**CITY OF NEWPORT BEACH**

**Re: Letter of Appeal for Revision of the Preliminary FIRM and BFE for the City of Newport Beach  
Community No.: 060227  
Case No.: 12-09-1324S  
Docket No. FEMA-B-1673**

**Figure 1. Sea Wall Survey Locations**

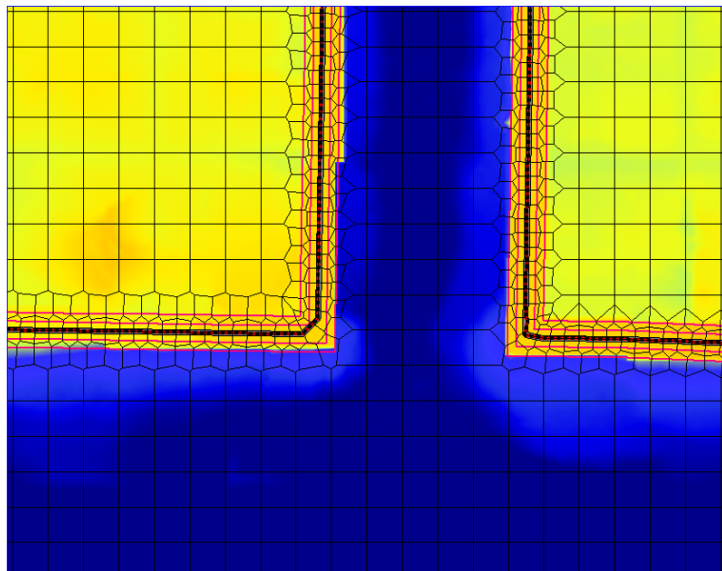
Within the Newport Bay and Harbor, most of the bayside shorelines along the Newport Peninsula and the entire Balboa Islands are protected from flooding by seawalls. Figure 1 shows the locations where seawall survey data were available and should be considered in the mapping of the flood boundaries. As shown in the figure, seawall elevation data for the Balboa Islands were collected by a Licensed Civil Engineer in 2010, and seawall elevation data along the bayside shorelines were collected by a Licensed Surveyor in 2017. These data are provided in the DVDs that accompany this letter, under the folder titled “Seawall Data.”

Figure 2. HEC-RAS Model Setup

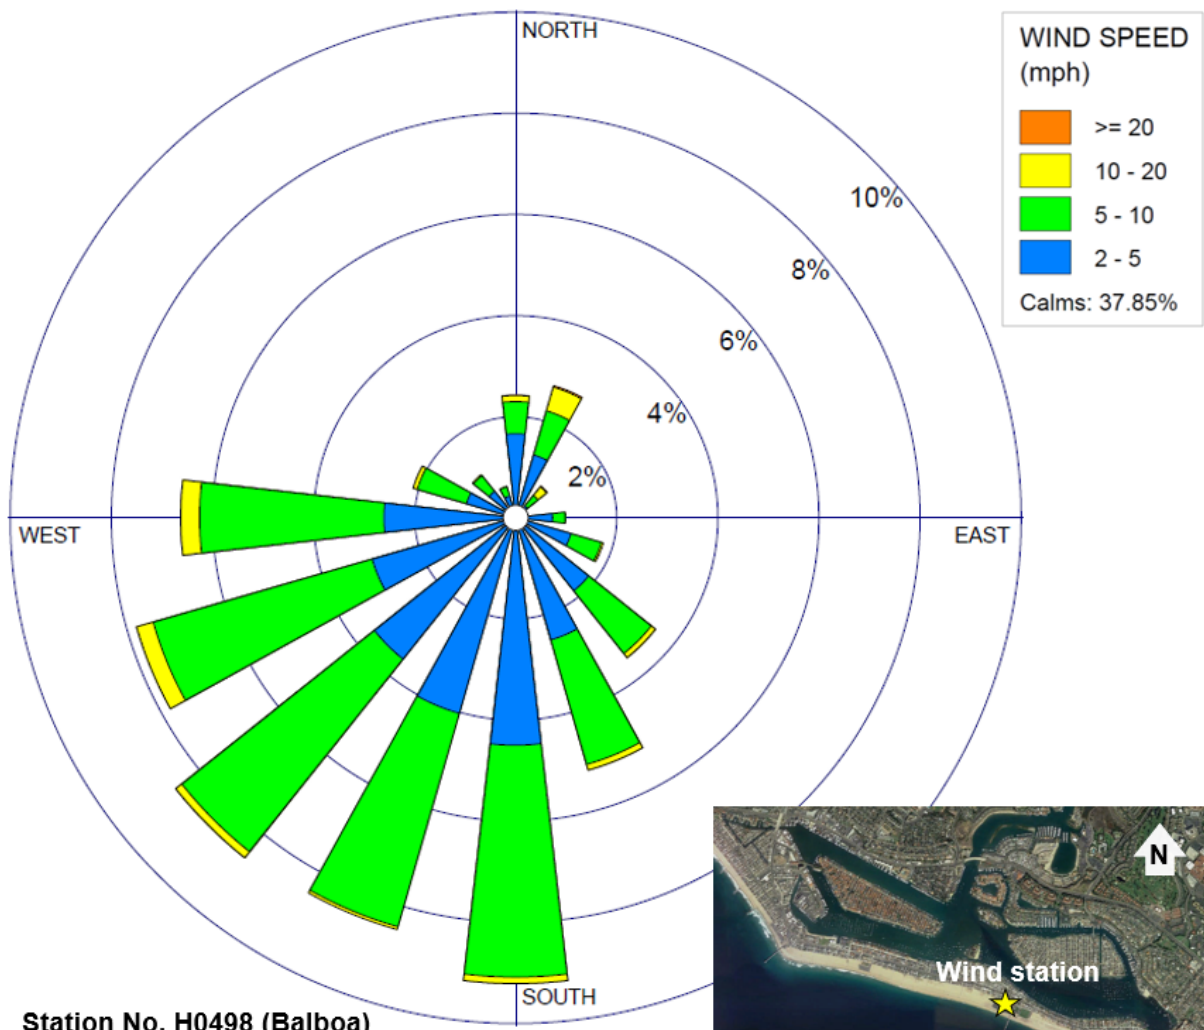
We believe that the use of 2D hydrodynamic modeling is critical for providing accurate flood mapping for the AE Zone of Newport Bay and Harbor. Hence, we used the FEMA-approved HEC-RAS model (version 5.0) to conduct flood modeling of the Newport Bay and Harbor. HEC-RAS version 5.0 includes 2D flood routing capabilities and allows a time-varying stage hydrograph that can be used to simulate tidal forcing at the ocean boundary. Figure 2a shows the HEC-RAS model domain for the Newport Bay and Harbor. In setting up the model, we started with the Newport Beach topographic data that was used in the Open Pacific Coast (OPC) Study and provided to us by Ms. Karin Ohman, and added the seawall elevation survey data to the model. Figure 2b provides an example of the model grid setup with seawall data. Specifically, the figure shows a zoomed view of the computational mesh, and the modeled seawall, which surrounds the corners of Balboa Island and Little Balboa Island.

**Figure 6. Comparison of Observed Flooding Extent with HEC-RAS Model Predicted Flooding Extent**

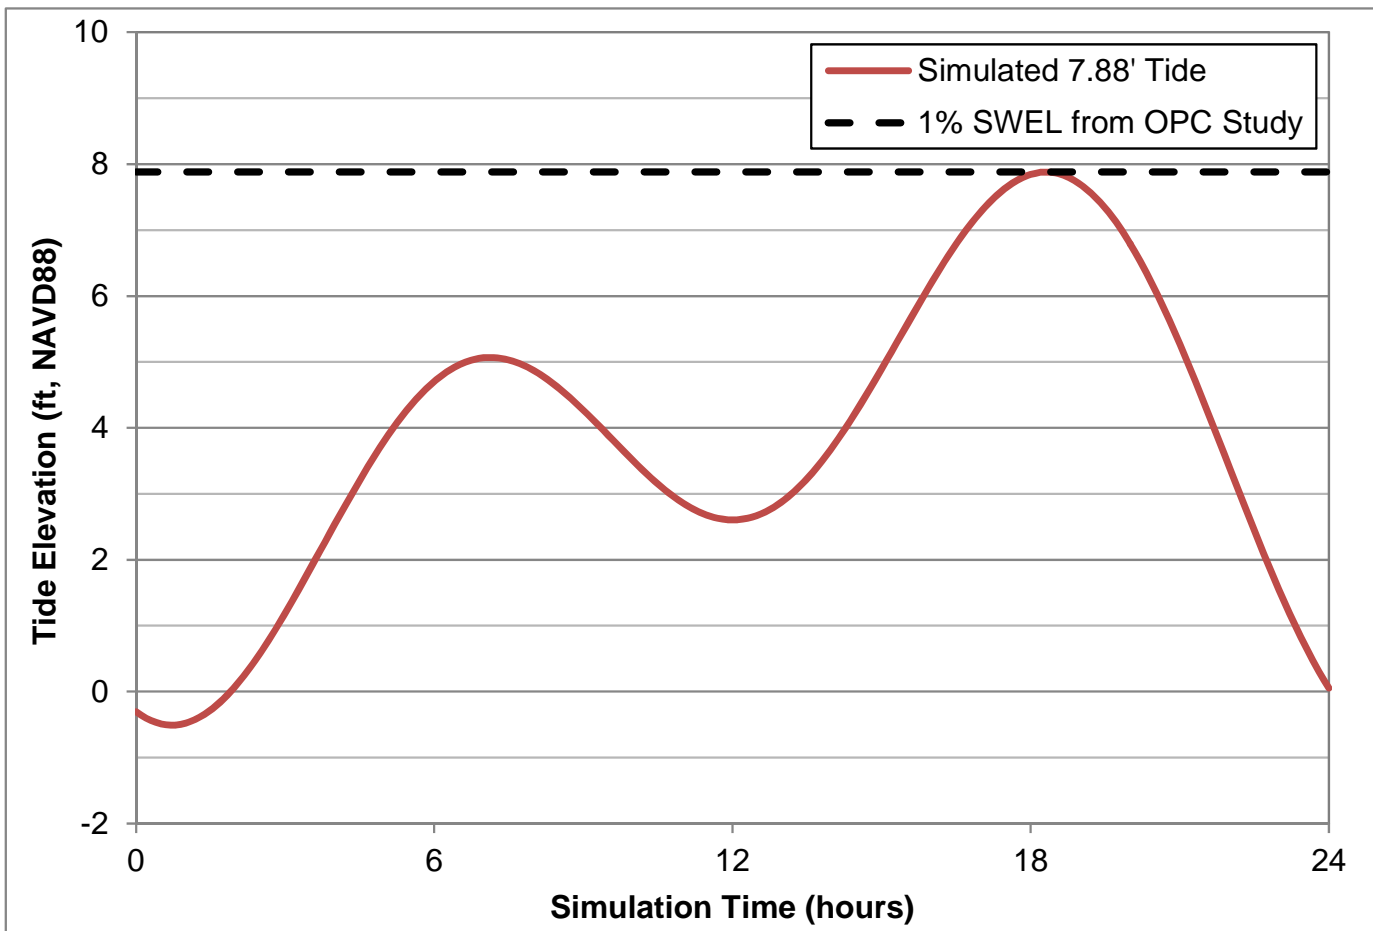
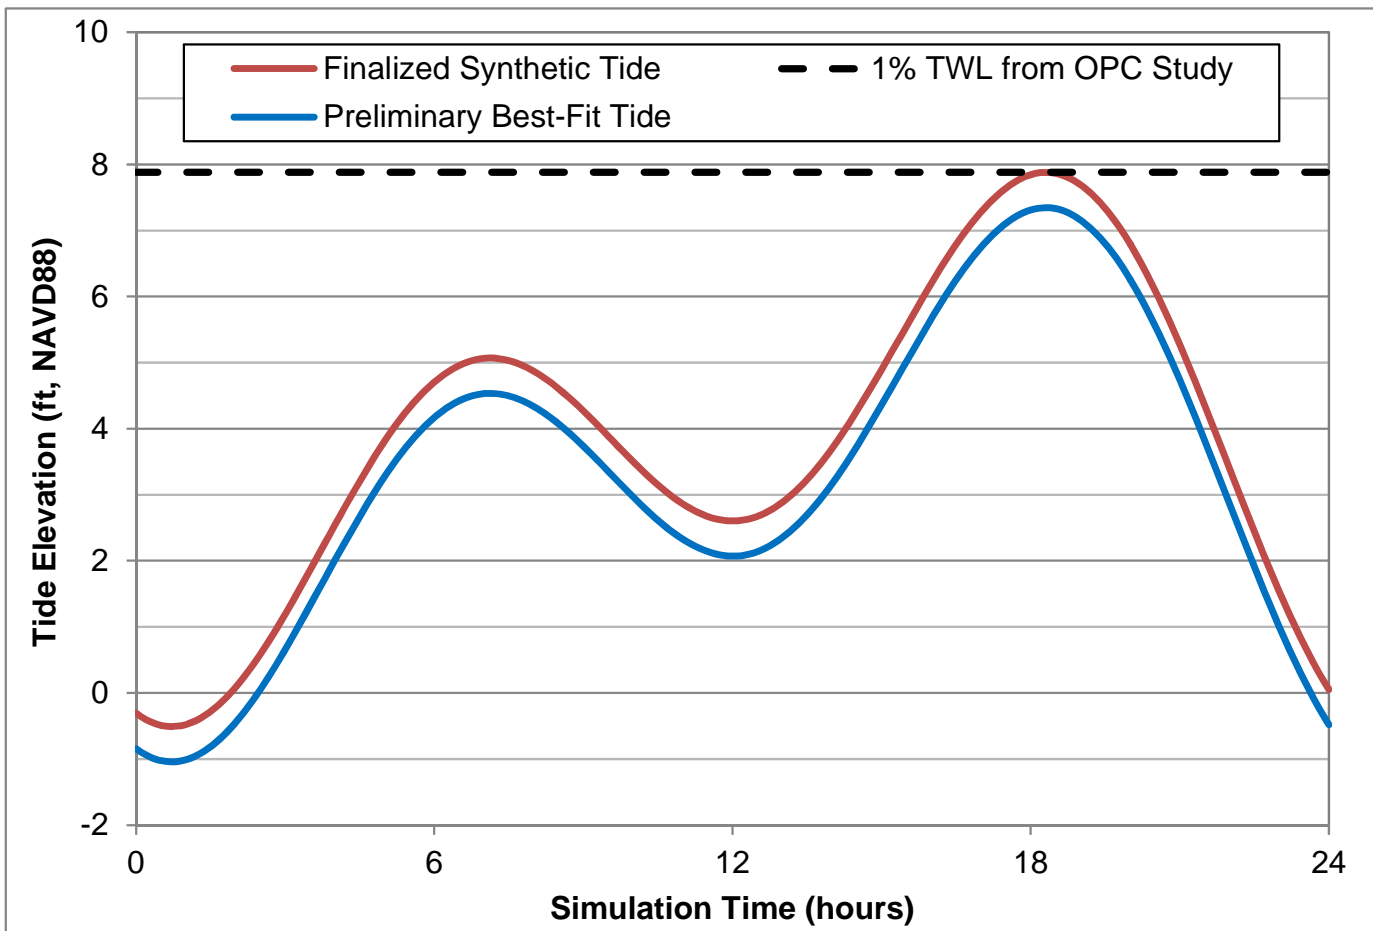
The HEC-RAS Model setup for Newport Bay was validated based on an extreme flood event that was observed on January 10, 2005, and documented in the UCI study (Gallien et al. 2011). During this flood event, the high tide was recorded as peaking at 7.73 ft., NAVD. To conduct model validation, a 24-hour tide (shown in Figure 5) recorded during this extreme flood event was downloaded from the NOAA website (NOAA 2017) and applied as the ocean boundary condition. In Figure 6, the result of the HEC-RAS model run is compared with the flood extent that was documented by Gallien et al. (2011), and based on 85 digital photos that cover the Newport Bay area and on eyewitness accounts. The figure shows that the flood extents predicted by the HEC-RAS Model match reasonably well with the observed flooded areas. The main discrepancy between the HEC-RAS Model validation results and the observed flood area consists of a small area along West Balboa Boulevard, from approximately 12th to 16th Street. In this area, field observations showed ponding, while HEC-RAS Model results did not. Since the field observations also showed this flooded area as being isolated and without visible connectivity to harbor waters, it is likely that the observed flooding in this area was due to ponding from rain or backflow from a storm drain(s) that was not closed in time to prevent floodwater intrusion.

**Figure 7. Simulated Tide Applied at the Ocean Boundary of HEC-RAS Model**

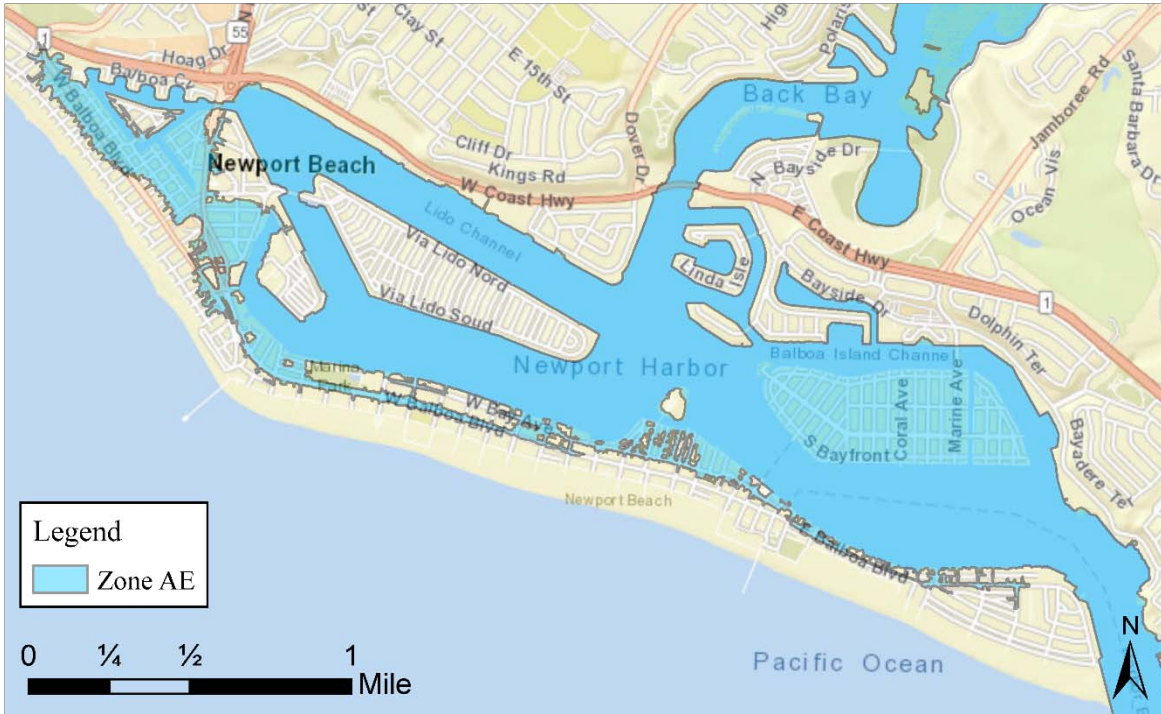
To map the AE Zone in Newport Bay, a 24-hour simulation was conducted using a 24-hour synthetic tide (Figure 7), specified as a time-varying stage hydrograph at the ocean boundary of the model domain. As shown in Figure 7, the tide has a peak at 7.88 ft., NAVD, which is consistent with the 1% still water

**Figure 8. Finalized and Preliminary 24-Hour Synthetic Tide - Based on the Ten Highest Observed Tides near Newport Beach**

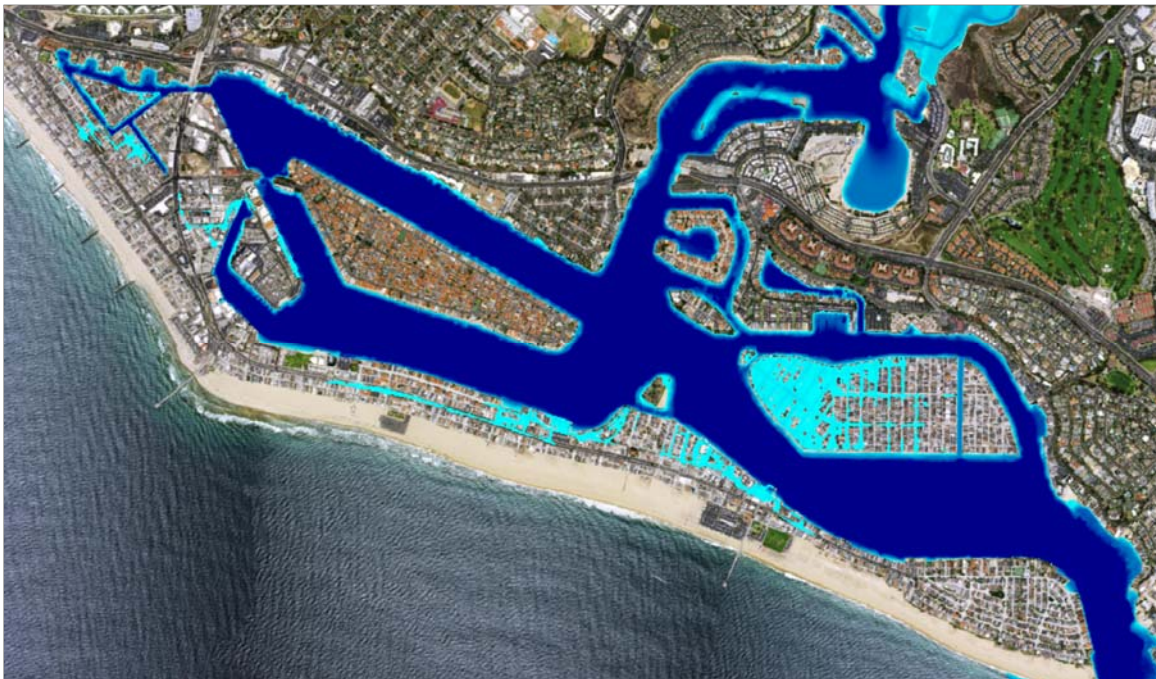
For each of the ten highest tides, a 24-hour time series was extracted from the observed data. The ten resulting time series were aligned at their peak tide values. To generate the synthetic tide, sine curves were fitted to the ten observed tidal series. The best fit for the synthetic tide series was achieved by optimizing the sine functions' amplitudes, frequencies, and phases to minimize the residuals between the synthetic tidal series and all ten observed tides. Next, the resulting best-fit series was adjusted so that its peak MHHW value matched the 1% TWL at Newport Bay from the OPC Study (7.88 ft., NAVD88). This was achieved by first computing the difference between the peak MHHW value and the 1% TWL, and then adding this difference to each of the values within the best-fit series. Figure 8 shows a comparison of the finalized synthetic tidal series and preliminary best-fit tidal series based on the ten highest observed tides.

Figure 9. Comparison of Preliminary FIRM AE Zone with the Proposed Revised Flood Zone

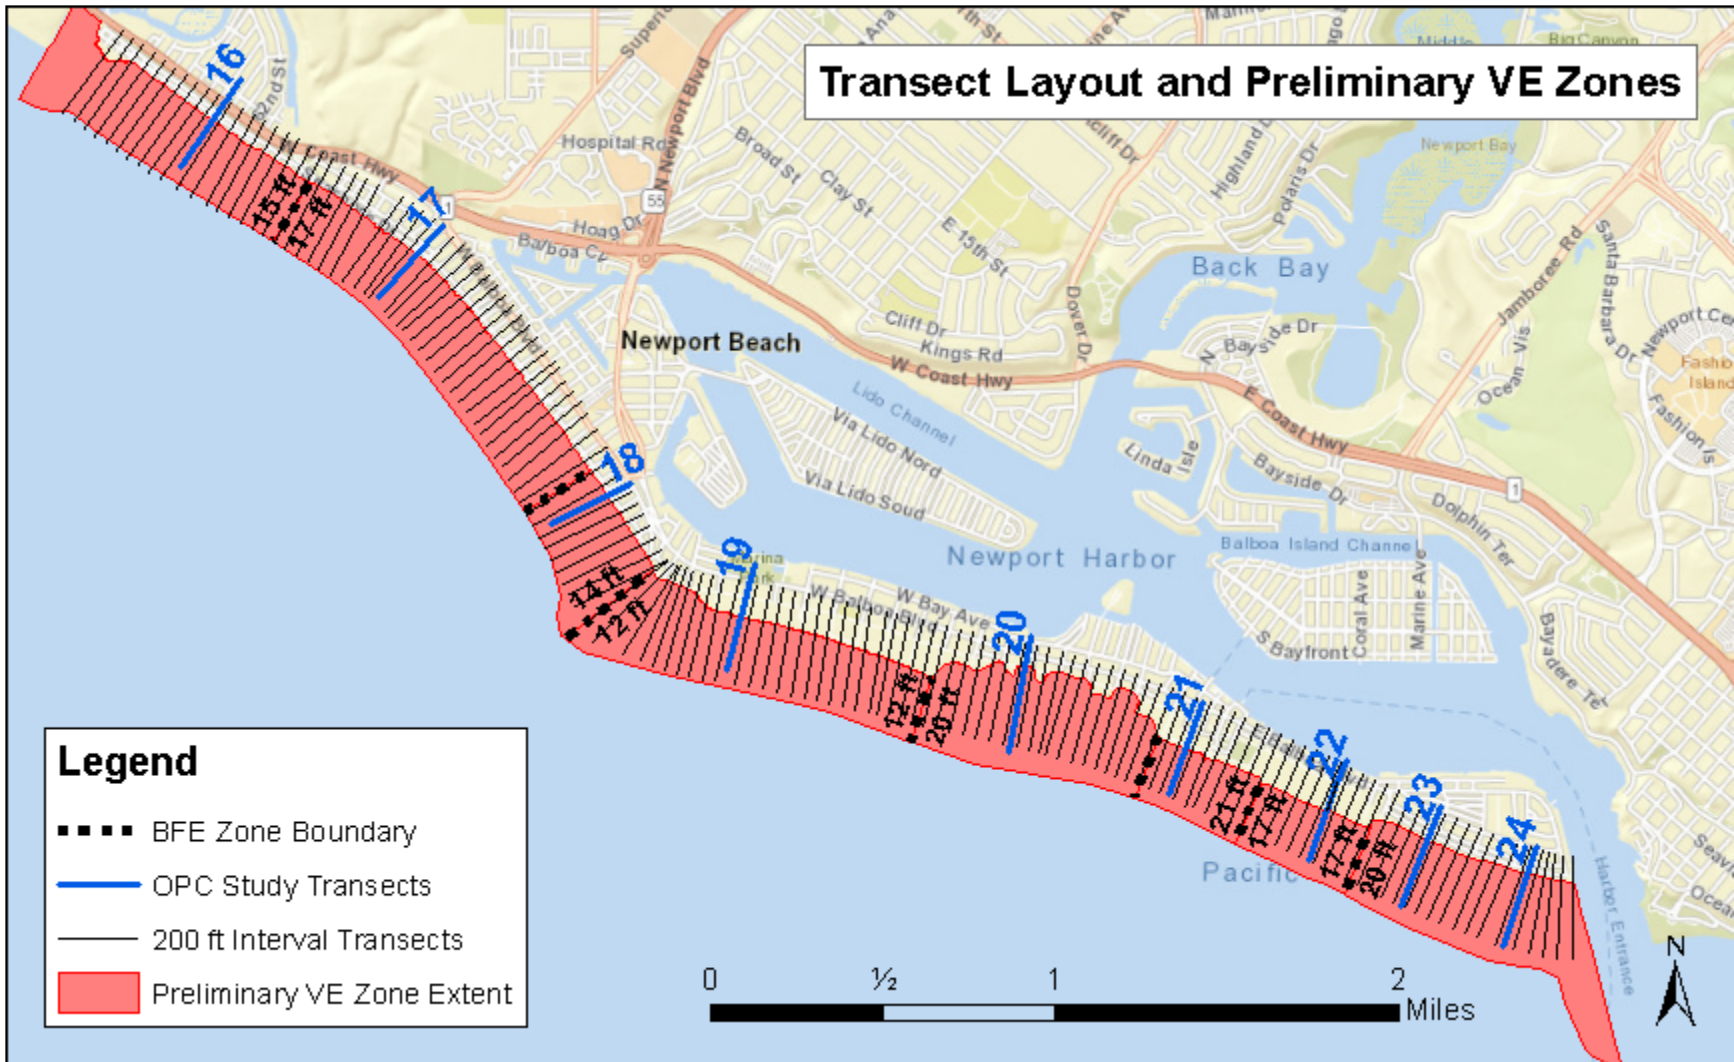
The boundary of the AE Zone was defined as the extent of flooding predicted by the HEC-RAS model. In Figure 9, we compared the flood zone areas that were predicted by the HEC-RAS model and the Preliminary FIRM. In the figure, the top panel (Figure 9a) shows the AE Zone that was mapped in the OPC study using the bathtub approach, while the bottom panel (Figure 9b) shows the AE Zone mapped using the HEC-RAS model. As shown in the figure, using a mapping approach that is based on the bathtub model results in a larger predicted flooding extent than does an approach based on the HEC-RAS model. This finding is consistent with the findings in Gallien et al. (2011). Since the bathtub approach substantially over-predicts inundated areas, we request that the Preliminary FIRM for the AE Zone be revised based on the accurate 2D model results, which have incorporated the seawall elevations along the shoreline.

1. Revise the FIRM for the AE zone to the proposed revised flood map shown in Figure 9b that was developed based on 2D hydrodynamic modeling, a scientifically accurate method. The FEMA method and assumptions (Bathtub model) are scientifically incorrect.
2. For the VE Zone, revise the BFEs to those shown Table 3. The proposed revised BFEs were developed based on an accurate use of the available beach slope data. In addition, revise the preliminary FIRM for Zone 16, 17, 18, 20, 22, and 23/24 to the proposed revised VE zone extents shown in Figures 15 to 20.
